SERVICE BULLETIN

SB-061517 REV C

DATE ISSUED: 6/23/2017
DATE EFFECTIVE: 6/23/2017
SUPERSEDES NOTICE: SB-061517-A/B
SUBJECT: Elevator Control Horn and Push tube rod end jam nut interference and elevator push tube modification
AIRCRAFT AFFECTED: **MODEL:** ICON A5
S/N: 00001, 00003 – 00020
REQUIRED ACTION:
1) Replace elevator push tube with new modified push tube
2) Inspect and correct as necessary light contact/interference between the elevator control horn and elevator push tube jam nut.

Figure 1: Interference between elevator control horn and elevator push rod jam nut

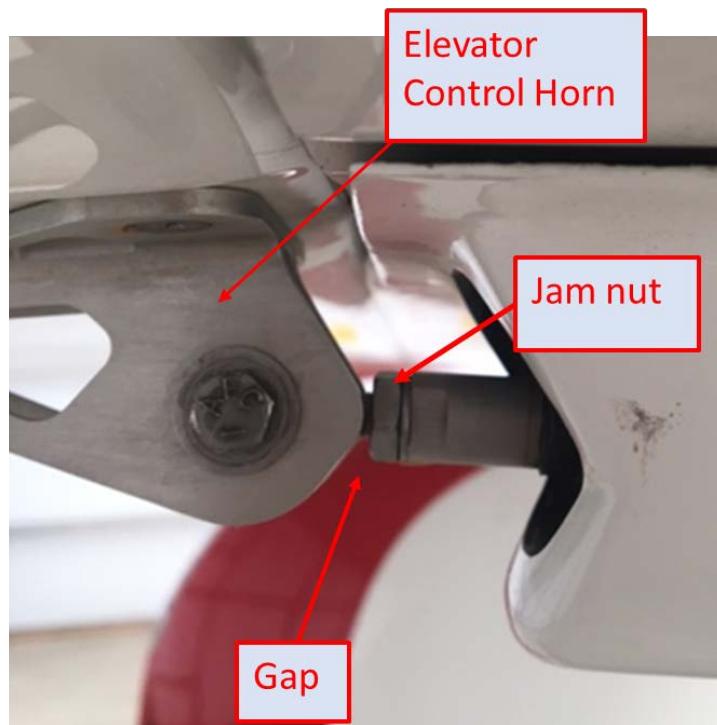
1. Visually inspect the elevator control horn to push rod connection point. If the rod end jam nut contacts the control horn at any time through the range of motion, as shown in Figure 1, replacement of the elevator control horn is required. Figures 2 and 3 show acceptable and unacceptable installations respectively.

Figure 4: Nutplate to Push Tube

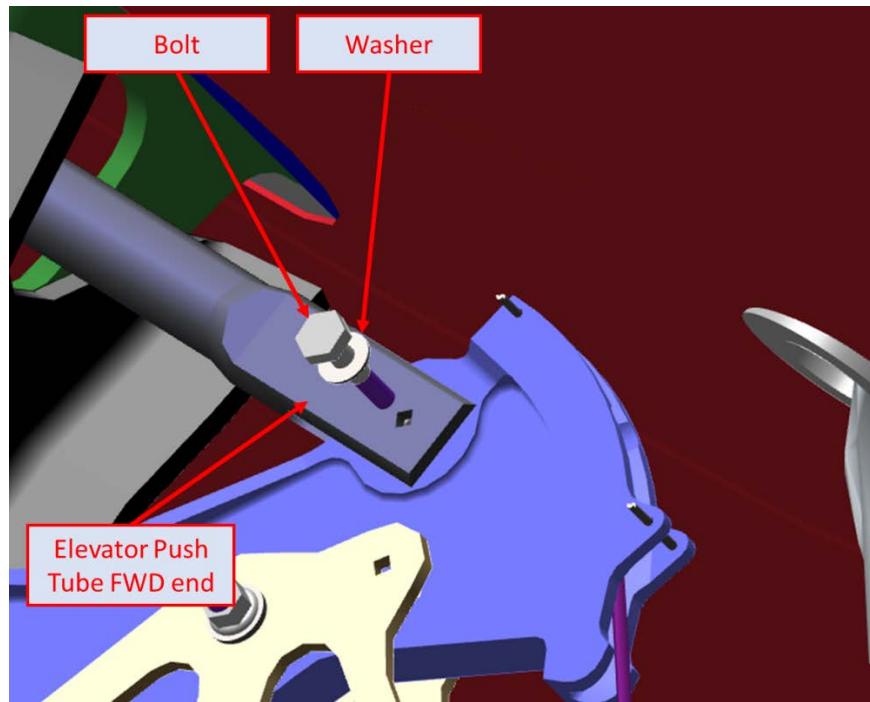
4. Bond CN609CR3P to one outboard flange surface using CB200. Prep the outside surface of the push tube at the nut plate by lightly sanding with 100-grit sandpaper and clean with isopropyl alcohol. Follow manufacturer's recommendations for preparation, application, cleanup, and curing, Figure 4.

Figure 5: Push tube to Pitch Control inside the tail

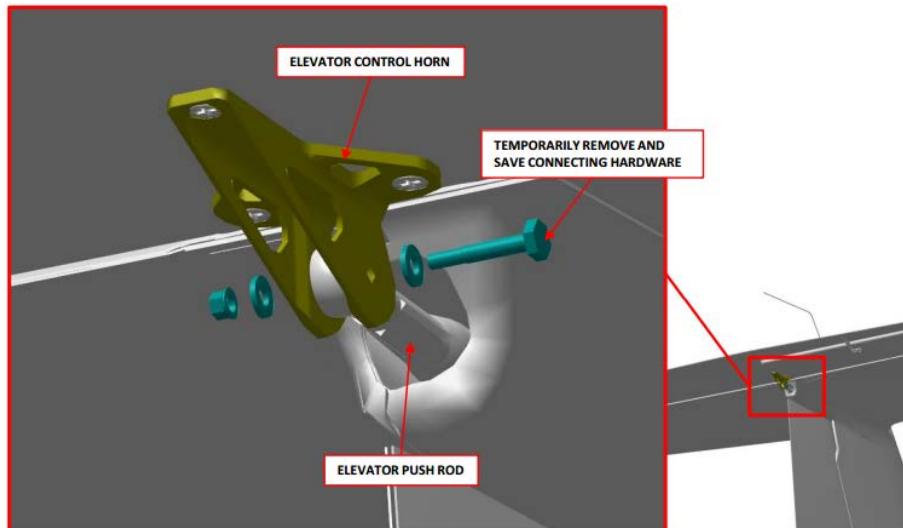
1. Remove aft plastic plug on left side of the horizontal/vertical tail to access the aft pitch sector assembly, Figure 5.
2. Disconnect elevator push tube at control horn and aft pitch sector and retain the hardware, Figure 5 and 6.
3. Remove elevator push tube and discard.
4. If the elevator control horn is damaged then remove elevator control horn and discard, Figure 7.
5. Using finger pressure, press on the bearing as if to slide the bearing out of the pitch sector. If bearing is loose on the pitch sector, carefully remove the bearing and discard, Figure 8.

7. Allow to cure. Follow manufacturer's recommendations for preparation, application, cleanup, and curing.
8. Install the elevator push tube in the tail with retained bolt (AN3C7A) and washer (NAS1149C0332R). Apply Tef-Gel to bolt threads. Torque to 26 inch-lbs. and apply torque stripe, Figure 5.

Figure 7: Control Horn Removal/Installation

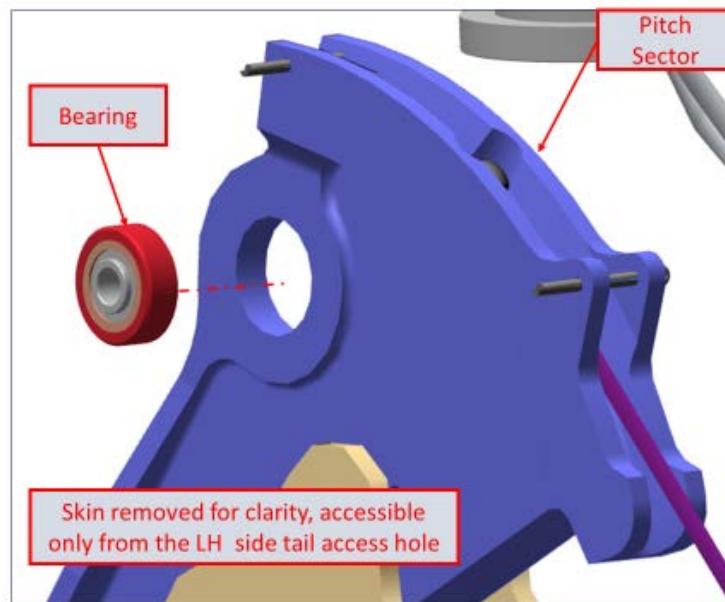
10. Replace the existing jam nut with AN316C4R. If present, remove and discard any washer found between the jam nut and the aluminum fitting in the push tube.
11. If the elevator control horn was removed due to damage then install as per step 9 otherwise proceed to elevator rigging instructions.
12. Install elevator control horn (ICA001860) onto elevator using 3x screws (MS24694C54 & MS24694C56). Apply Tef-Gel to screw threads, Figure 7.
13. Torque fasteners to 26 inch-lbs., and apply torque stripe.
